# CITY OF ALBUQUERQUE

RE: **Lot 15 Block 9 Unit 22 SAD 228  
6419 Petirrojo Rd. NW  
Volcano Cliffs Subdivision  
Grading and Drainage Plan  
Engineers Stamp Date 1/26/2021 (D10D003Q15)**

## DRAINAGE AND TRANSPORTATION INFORMATION SHEET (REV 6/2018)

<div>ENGINEER'S SEAL</div> <div></div> <div>1/26/21</div> <div>DAVID SOULE P.E. #14522</div>	6419 PETIRROJO	DRAWN BY: WCMJ
	GRADING AND DRAINAGE PLAN	DATE: 1-26-21
	 1606 CENTRAL AVENUE SE SUITE 201 ALBUQUERQUE, NM 87106 (505) 872-0989	21021008-LAYOUT-1-26-21 SHEET # JOB # 21021008

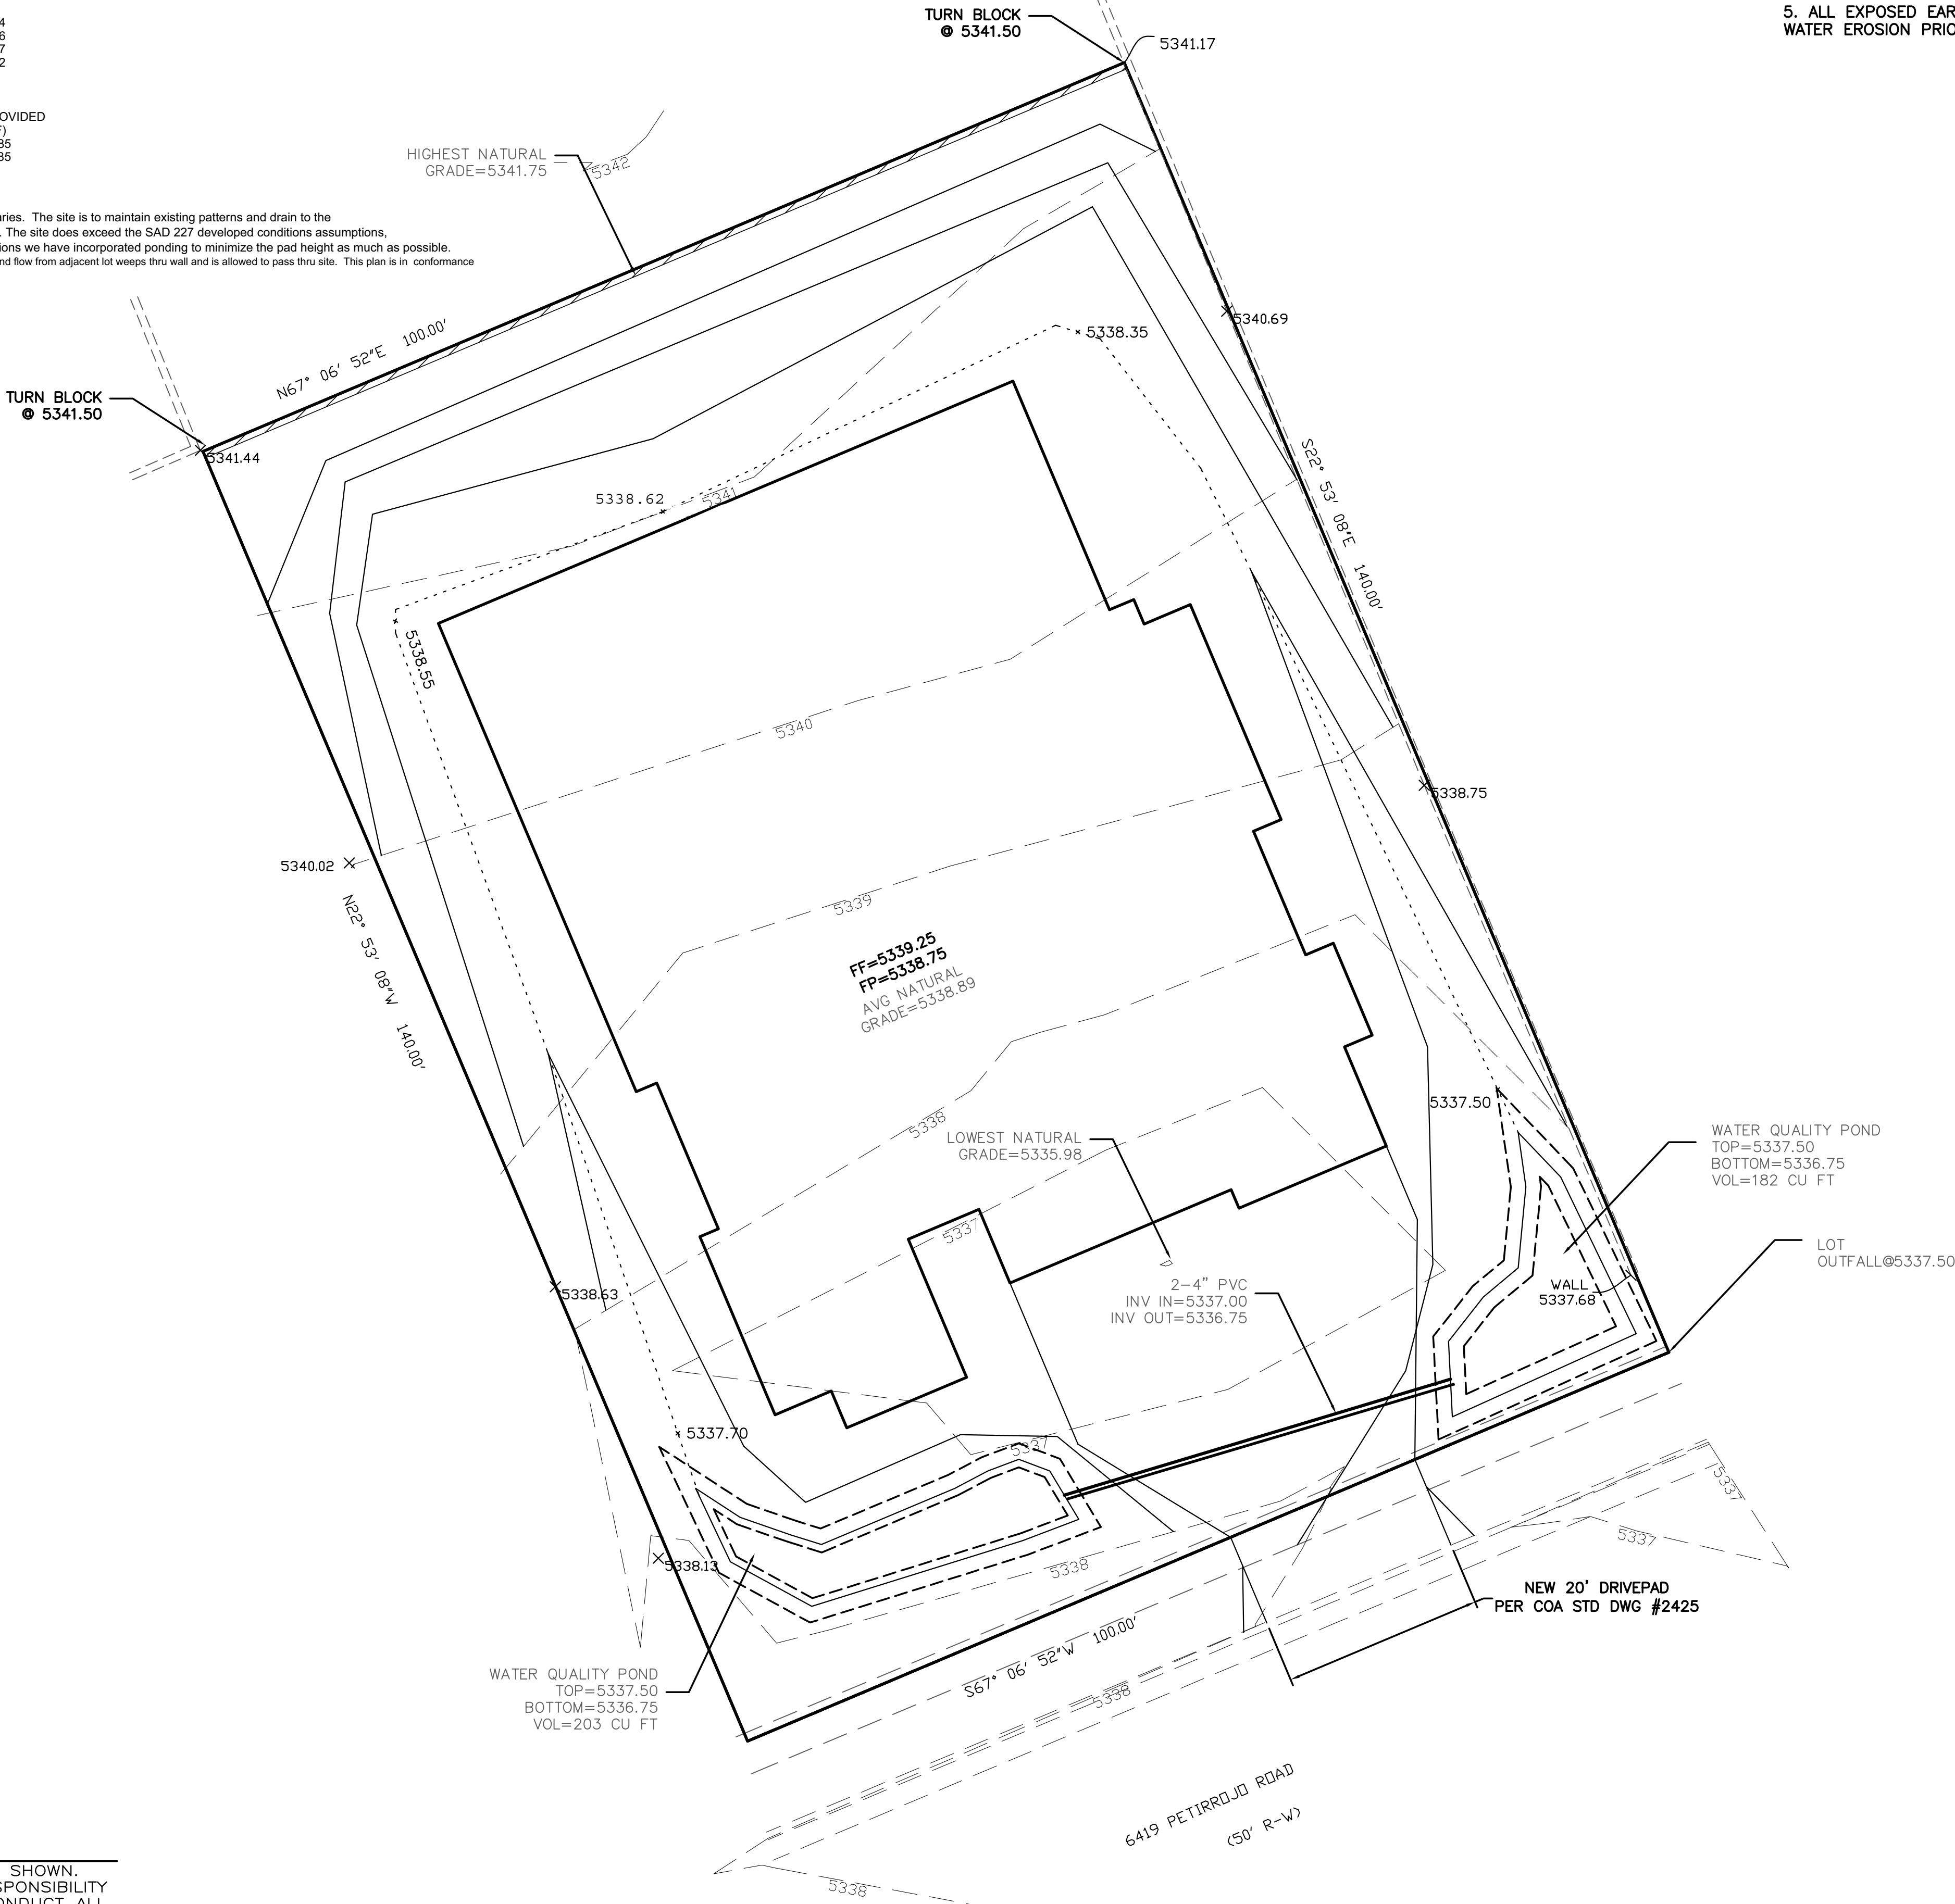
Based upon the information provided in your submittal received 1/27/2020, this plan is approved for Grading Permit.

**Prior to Building permit approval a Pad Certification will be required, provided by the Engineer or a registered Land Surveyor.**

**Advise the owner contractor not to use dirt as a ramp to climb the curb, use lumber or crusher fines for this purpose.**

Reiterate to the Owner/Contractor that a separate permit for a garden/retaining wall must be obtained with the approved G&D plan and Pad Certification. Also, if a swimming pool is to be placed the grading and drainage plan will change and will need to be resubmitted.

**Prior to Certificate of Occupancy release, Engineer Certification per the DPM checklist is required.**
